STATE OF NEW HAMPSHIRE  
INTER-DEPARTMENT COMMUNICATION

**FROM:** Wayne Wheeler, P.E.  
Permitting & Design Review Section

**SUBJECT:** Stage 1 Phase 1 Anchor Trench Repairs/NCES/Bethlehem/  
DES-SW-SP-03-002

# NCES Secondary Leachate Flows

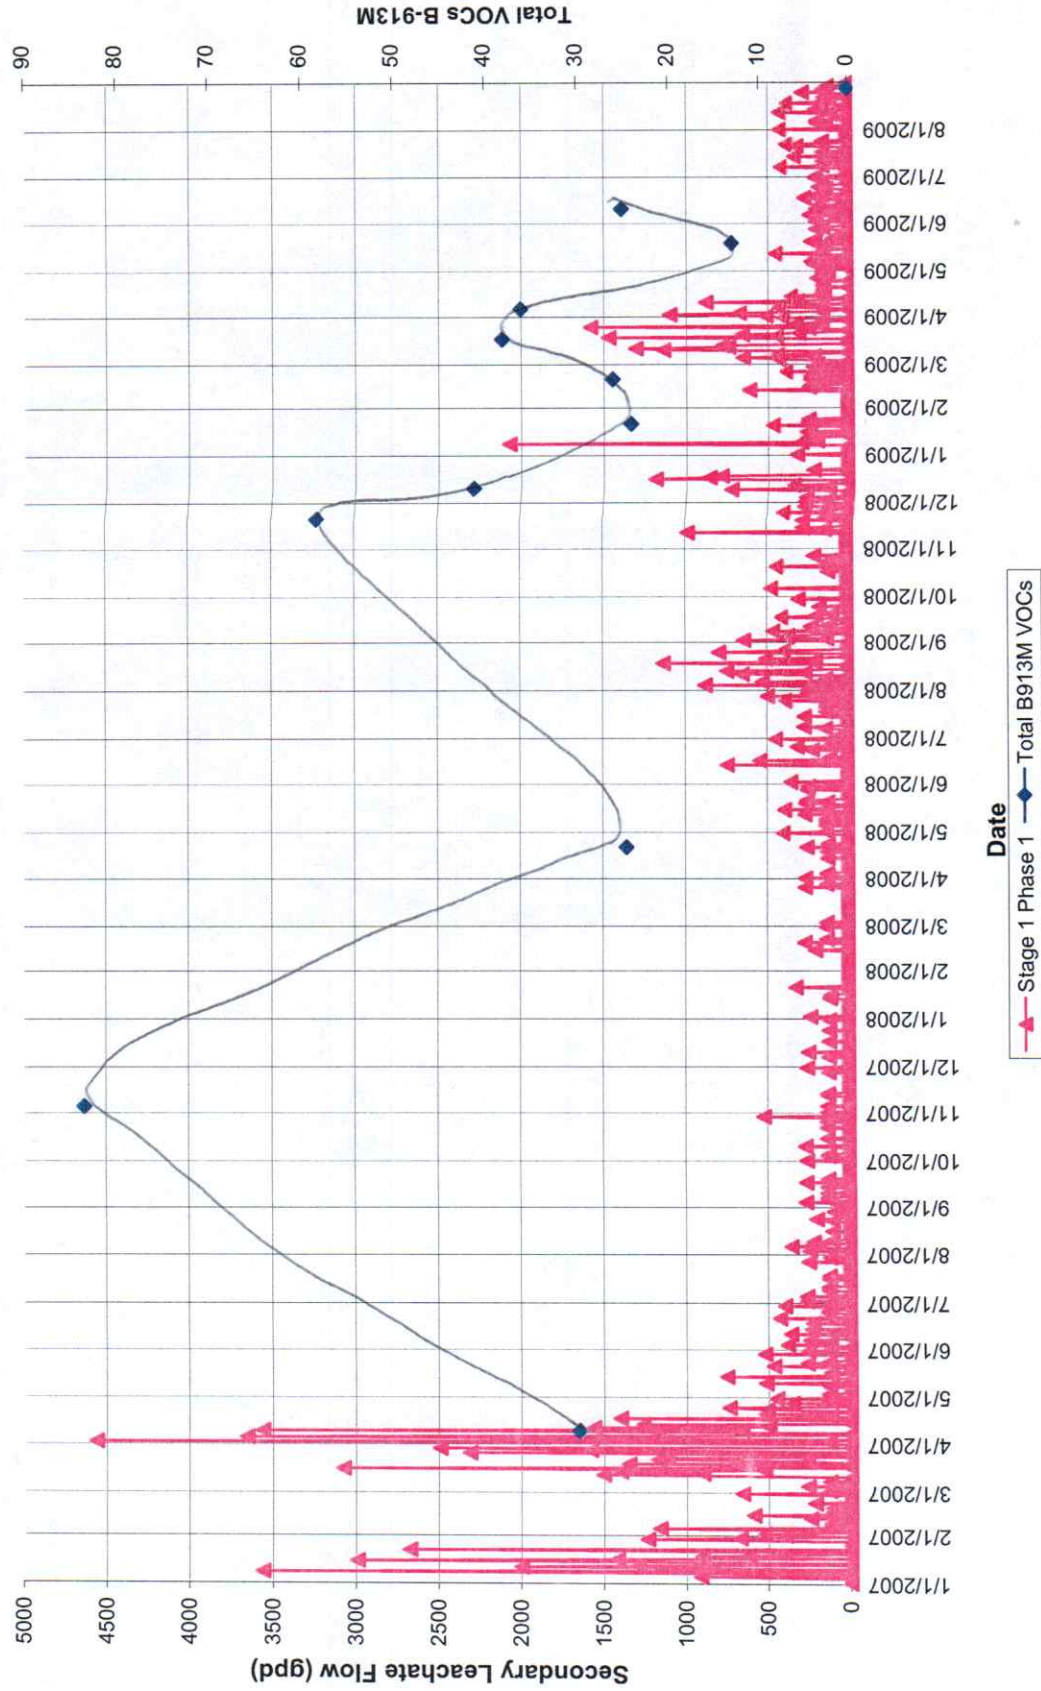
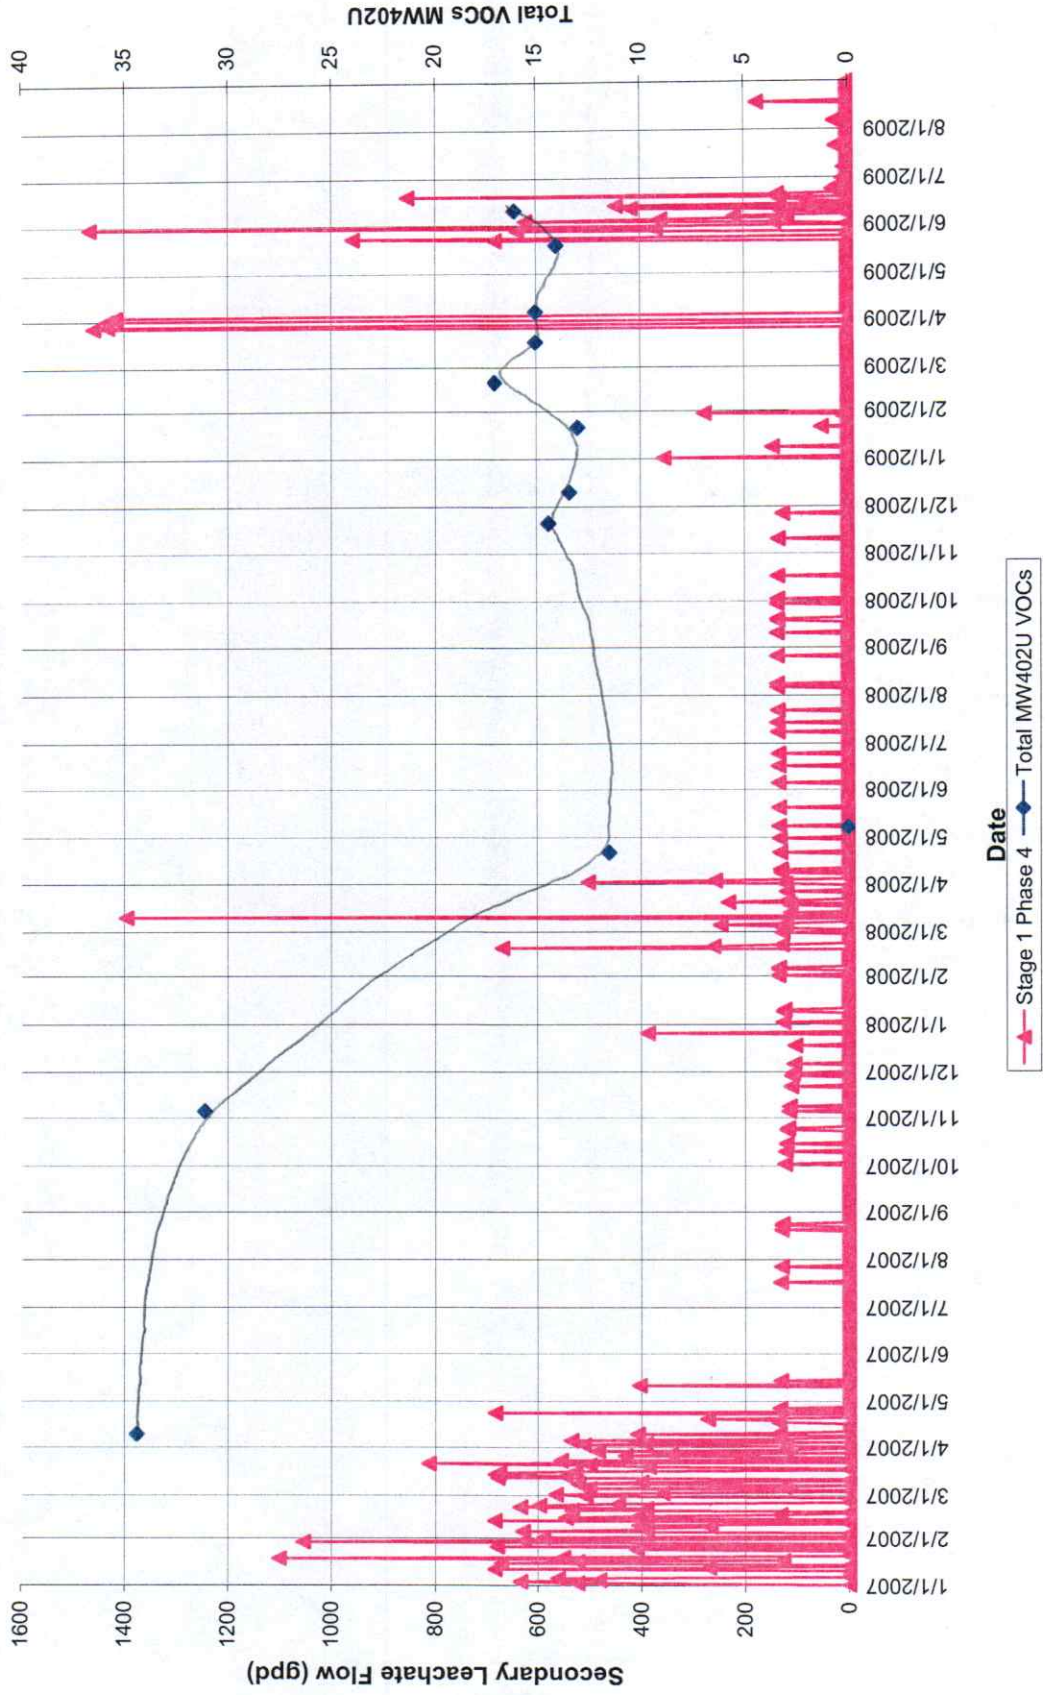
As shown on the attached charts, Stage 1 secondary flows appear to be influenced by either rainfall events or runoff. In addition and as shown on the attached charts, there appears to be a relationship between total VOCs measured at MW B-913M and secondary leachate flows. I have also plotted Total VOCs for each of the Stage 1 phases.
